**RESPONSE TO SUBMISSIONS – S75W MODIFICATION APPLICATION TO  
BARANGAROO CONCEPT PLAN MP06-0162 (MOD 11)**

Supplementary Transport Assessment

## **Road Safety Audit**

Concept Design Stage

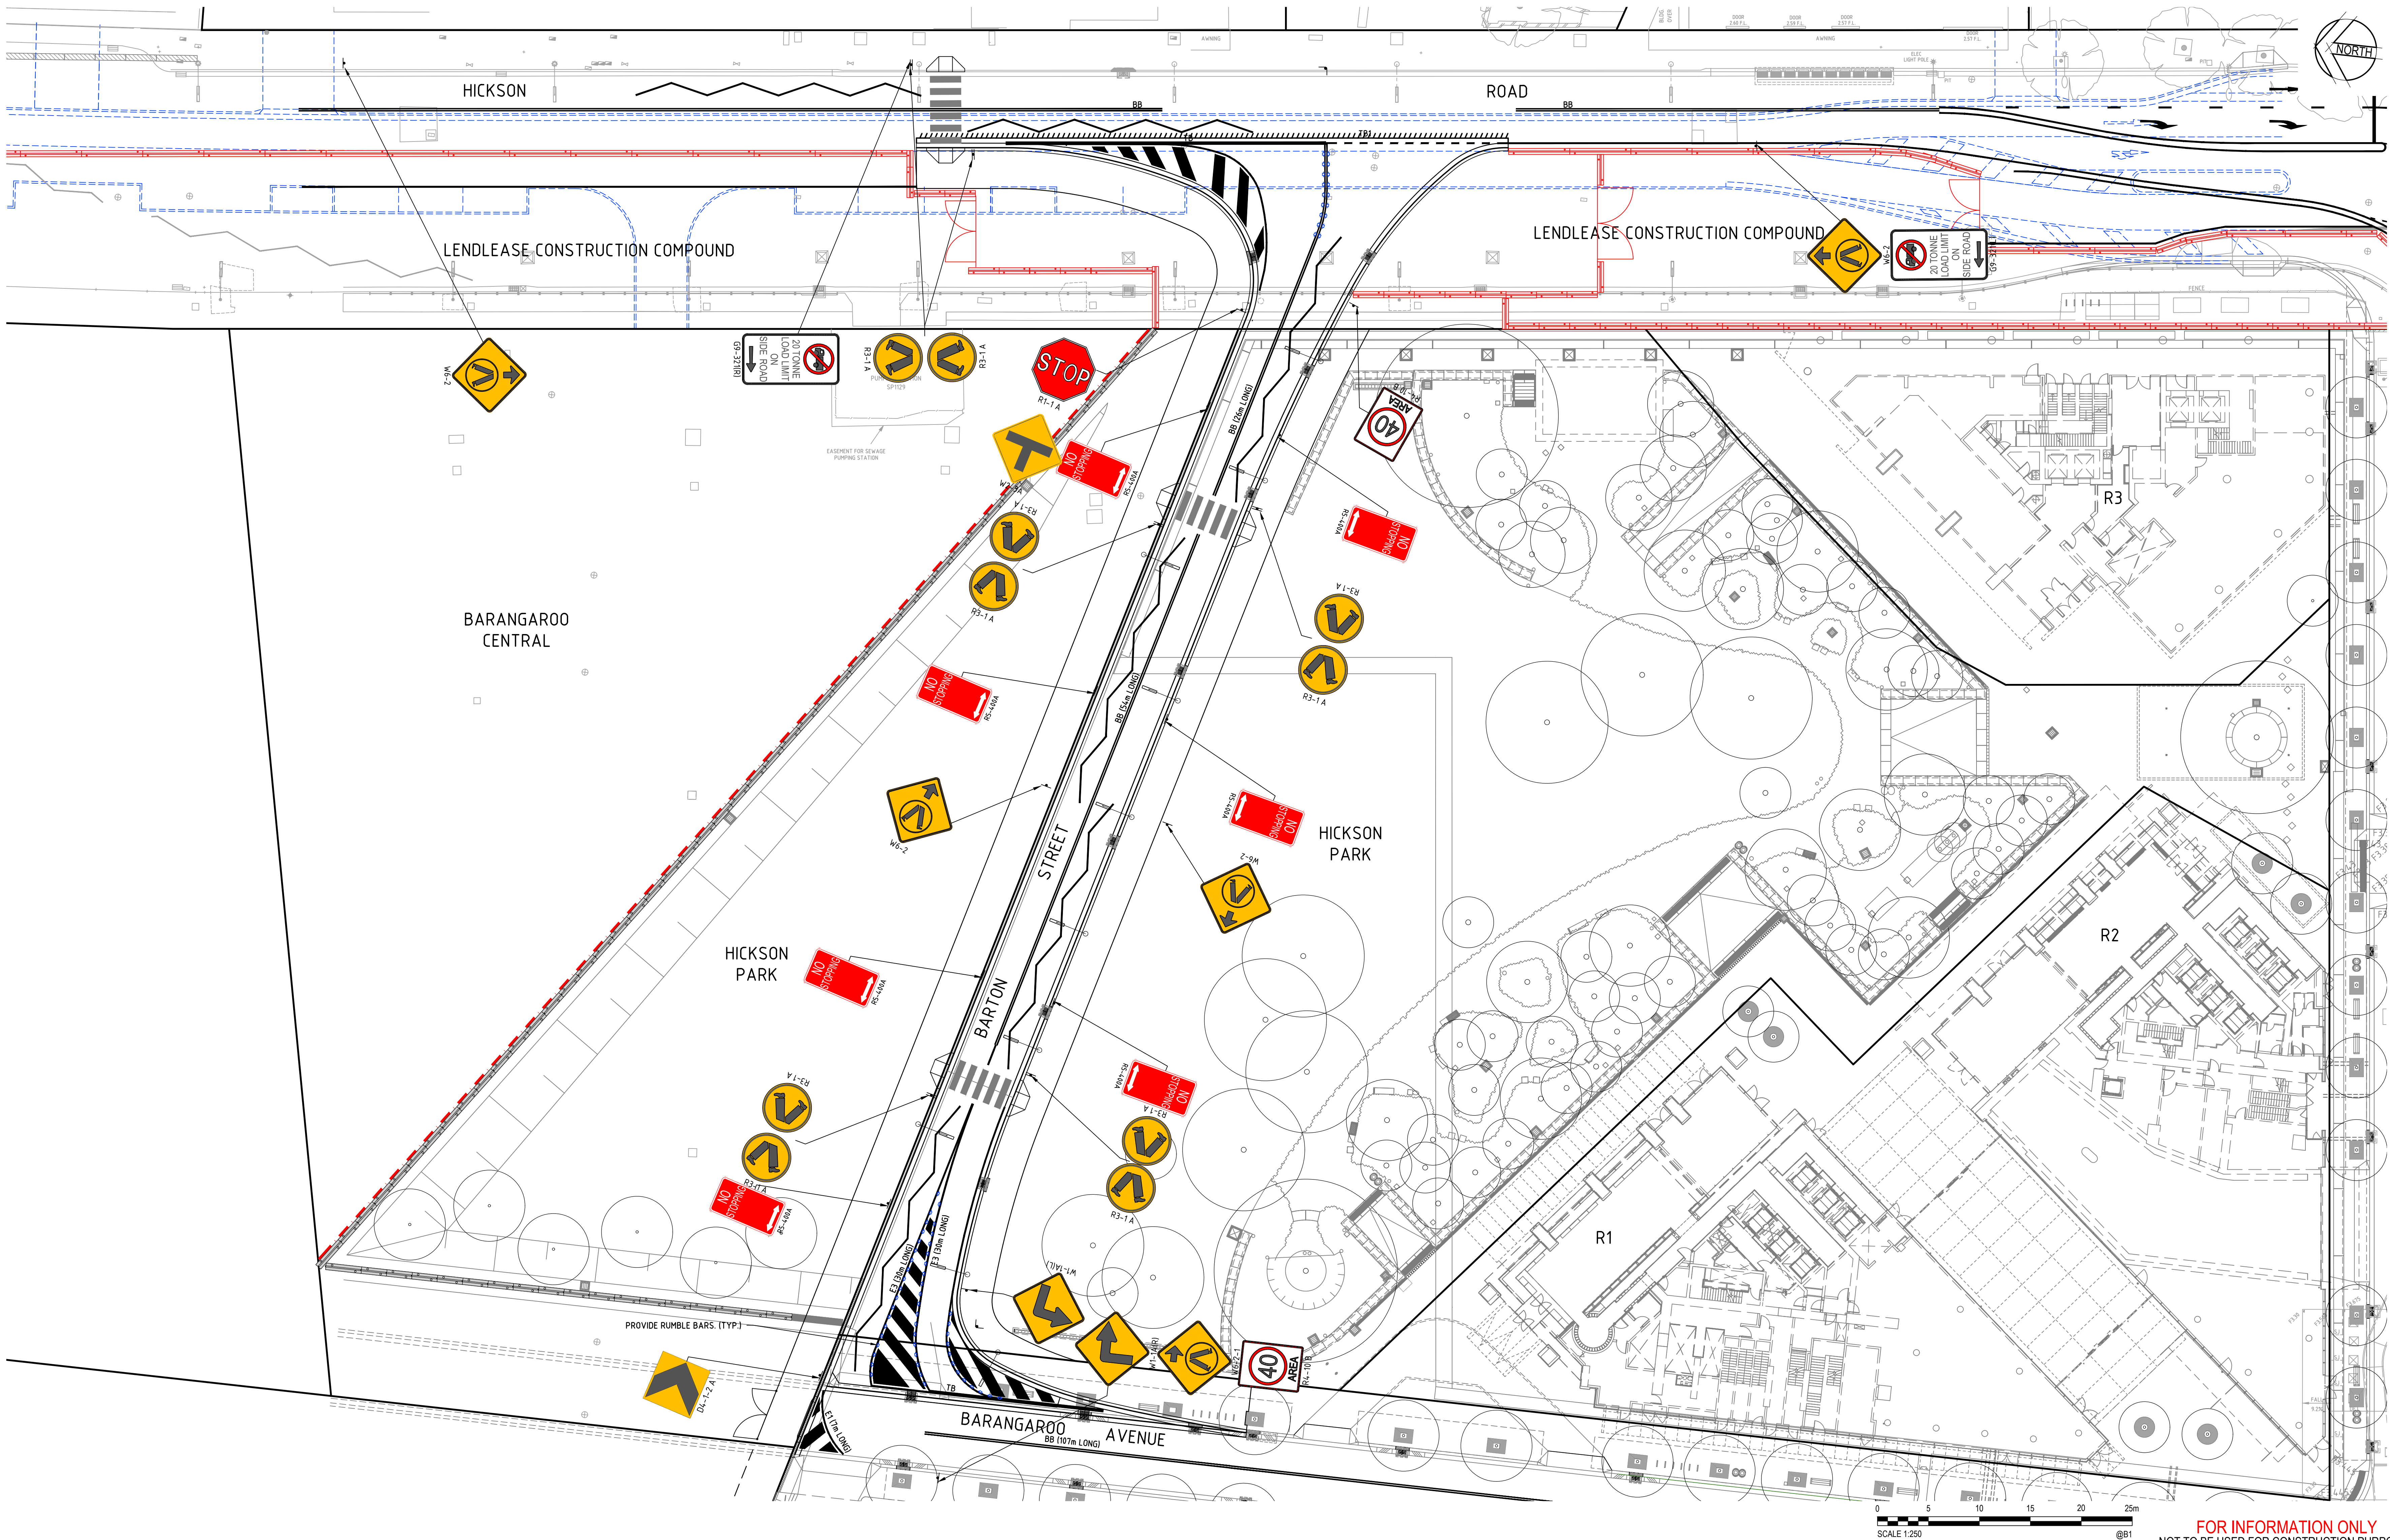
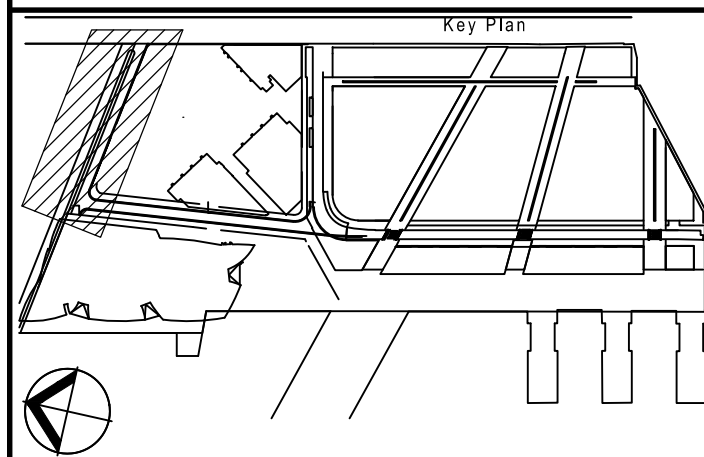
- A concept plan showing existing and proposed lane arrangements for Hickson Road including at intersections with both Barton Street and Watermans Quay;

- **Proposed lane arrangements and concept plan** - A concept plan indicating the proposed lane arrangements, line-marking details and signage controls was previously prepared by Cardno as part of the Barton Street Temporary Construction Road Review of Environmental Factors (REF) which was determined by INSW in June 2020. A copy of the concept plan is included in Figure 3 of the JMT supplementary transport assessment.

A concept plan indicating the proposed lane arrangements, line-marking details and signage controls was previously prepared by Cardno as part of the Review of Environmental Factors (REF) which was determined by INSW in June 2020. This REF permits the temporary use of Barton Street as a construction only road. While the modification to the concept plan would expressly permit both construction and non-construction vehicles to use Barton Street, the layout and design of the road would remain unchanged from that shown as part of the REF drawings. This concept plan layout is provided in Figure 3 on the following page.

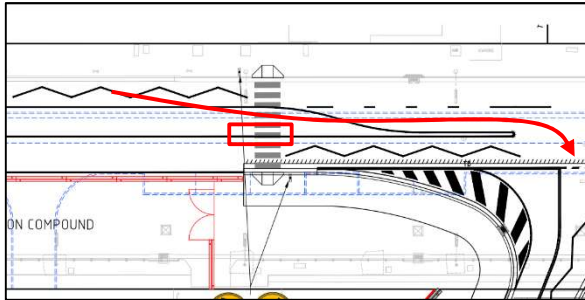
<p><b>9.</b> Pedestrian Crossing Sheet 300</p>	<p>There is a pedestrian crossing through a painted median.</p> <p>The median line marking cuts through the pedestrian crossing.</p> <p>There is a risk that there may be confusion as to who has right of way resulting in pedestrian-vehicle collisions.</p> <p>There is a right turn bay adjacent to the pedestrian crossing.</p>	<p>Occasional</p>	<p>Serious</p>	<p>High</p>	<p>Hickson Road median to be removed given that no right turn bay is required.</p> <p>Pedestrian crossing now over 2 lanes.</p> <p>Refer to revised Barton Street REF drawings.</p>

There is a risk that a vehicle attempting to enter the right turn bay may overhang or block the pedestrian crossing resulting in pedestrians attempting to move between vehicles and pedestrian-vehicle collisions.

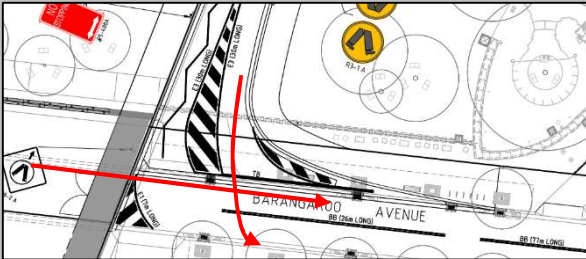
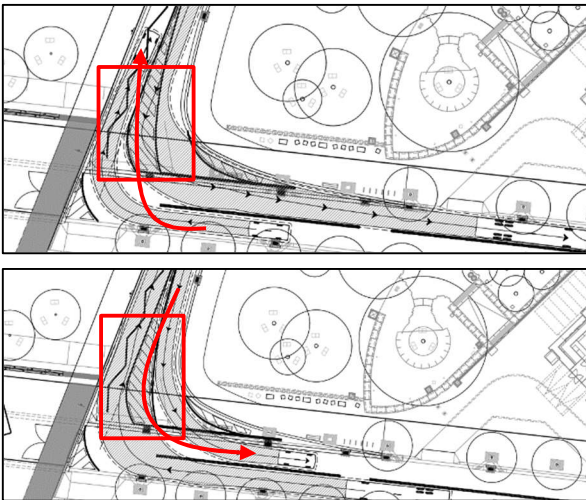
<b>13.</b> Additional Turning Paths Sheet 800	<p>There is no Right Turn In shown for Barton Street for large vehicles.</p> <p>There is no restriction provided on vehicles undertaking these movements.</p> <p>No further assessment has been carried out.</p>	Note			<p>Traffic modelling and assessment suggest very low heavy vehicle traffic travelling southbound on Hickson Rd and turning right.</p> <p>No right turn for larger vehicles signage added. Refer to revised Barton Street REF drawings.</p>

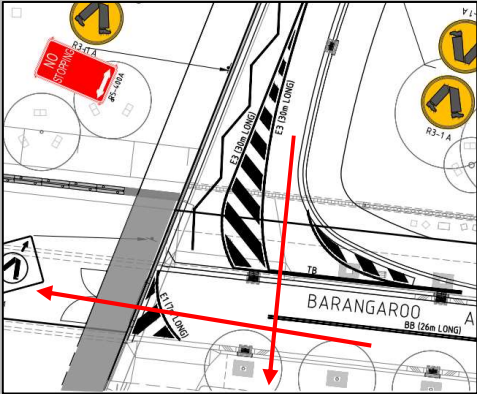
<b>15.</b> Centre Median Sheet 801	<p>There is a centre median that is being used as potential swept path area for both directions of travel.</p> <p>There is a risk that concurrent opposing turning vehicles may both enter the centre median resulting in head on or sideswipe collisions.</p>	Occasional	Minor	Medium	<p>There is insufficient space to widen the intersection to allow two heavy vehicles to pass each other.</p> <p>Heavy construction vehicle movements will be coordinated to ensure a one-way circulation plan, which minimises the probability of two large vehicles driving towards each other.</p> <p>In the low probability of two large vehicles making the turn, there sufficient sight distance at the intersection to allow for large vehicles to suitability give way to oncoming traffic if they are using the central median to make the turn.</p>

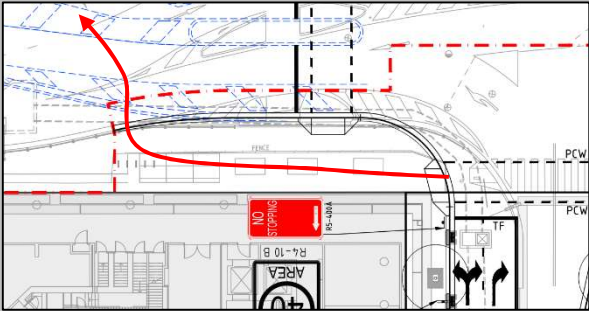
<b>17.</b> Speed Zones Sheet 045	<p>There is no indication of the proposed speed zone at Barton Street during Roadworks, in the interim and in the final arrangements.</p> <p>There is a risk that vehicles may travel at a higher speed than designed for resulting in run off road impacts or pedestrian-vehicle collisions.</p> <p>This risk is increased where it appears to be a requirement to signpost the speed zone of Watermans Quay but Barton Street has been left out.</p>	Improbable	Minor	Low	<p>Speed limit (40km/hr) signage added.</p> <p>Refer to revised Barton Street REF drawings.</p>
<b>One Sydney Harbour – Proposed Public Domain Works (SSD7944)</b>					
<b>18.</b> Additional Turning Paths Sheet 016	<p>There is no Left turn into Watermans Quay for large vehicles.</p> <p>There is no restriction provided on vehicles undertaking these movements.</p> <p>No further assessment has been carried out.</p>	Note			<p>Drawing CD2900019 shows a 12.5m turning left from Barangaroo Ave into Watermans Quay and into the basement ramp with no issues.</p>

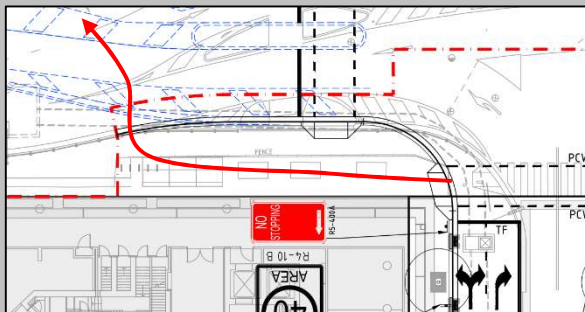
<b>21.</b> Pedestrian-worksite access. Sheet 045	<p>It is unclear to the audit team of proposed pedestrian desire lines, access points and conflicts with worksites and worksite accesses.</p> <p>Of particular concern is the northwest corner of Watermans Quay, where the pedestrian path extends past the pedestrian crossing and to the worksite vehicle access.</p> <p>There is a risk that a pedestrian may access worksite areas resulting in trip/fall injuries; or impacts with worksite vehicles.</p>	Probable	Serious	Intolerable	<p>The design on drawing CD2000045 shows the footpath connection arrangement in the ultimate case. The footpath will tie into the exiting Hickson Road. In this situation, there will a signalised intersection and there will be no construction compound.</p> <p>The signalised intersection is shown in separate documentation and proposed to be constructed prior to the documentation on drawing CD2000045.</p> <p>Interim measures, which includes the consideration of pedestrians and vehicles around the Hickson Road construction compound is considered in separate design documentation.</p>

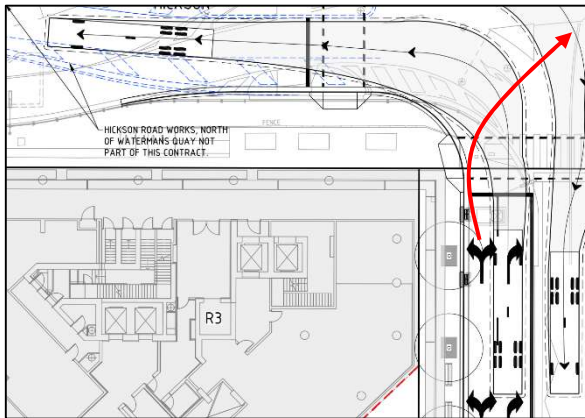
<p><b>23.</b> Cyclist Line marking and Separation Sheet 015</p>	<p>It is unclear to the audit team to the function and purpose of the proposed cycleway line marking, kerbing and lanes.</p> <p>There is 2-way travel proposed with no northbound termination, directing cyclists into oncoming vehicles.</p> <p>There is no signage provided to alert motorists or cyclists of the proposed arrangement.</p> <p>There is a risk that a through vehicle may impact a cyclist.</p>	<p>Probable</p>	<p>Serious</p>	<p>Intolerable</p>	<p>Drawings updated to change to one-way cycle way (southbound only) on the eastern side of Hickson Rd.</p> <p>See revised OSH public domain drawings.</p>

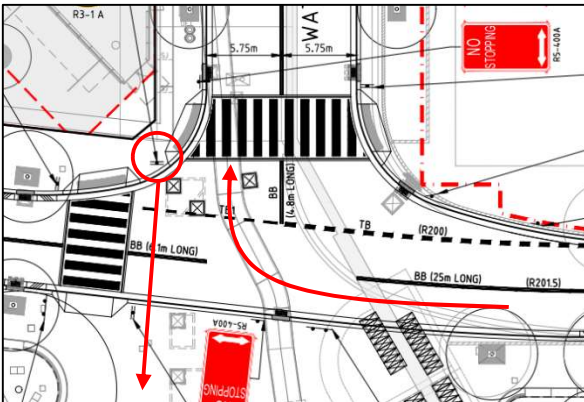
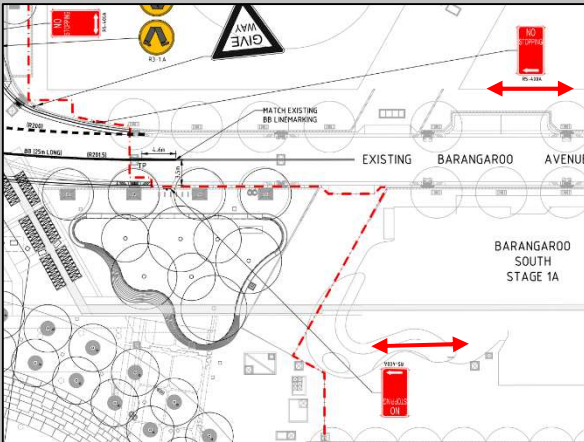
27. Intersection Delineation Sheet 047	There is limited visual cues provided to motorists of the proposed T-Intersection.	Improbable	Minor	Low	T junction signage added.
	There is a risk that a vehicle may not anticipate the intersection layout and approach the intersection with insufficient time to slow to negotiate the intersection resulting in run off road incidents or impacts with opposing vehicles.				Bollards and signage provide visual cue to also notify drivers of upcoming T intersection. See revised OSH public domain drawings.
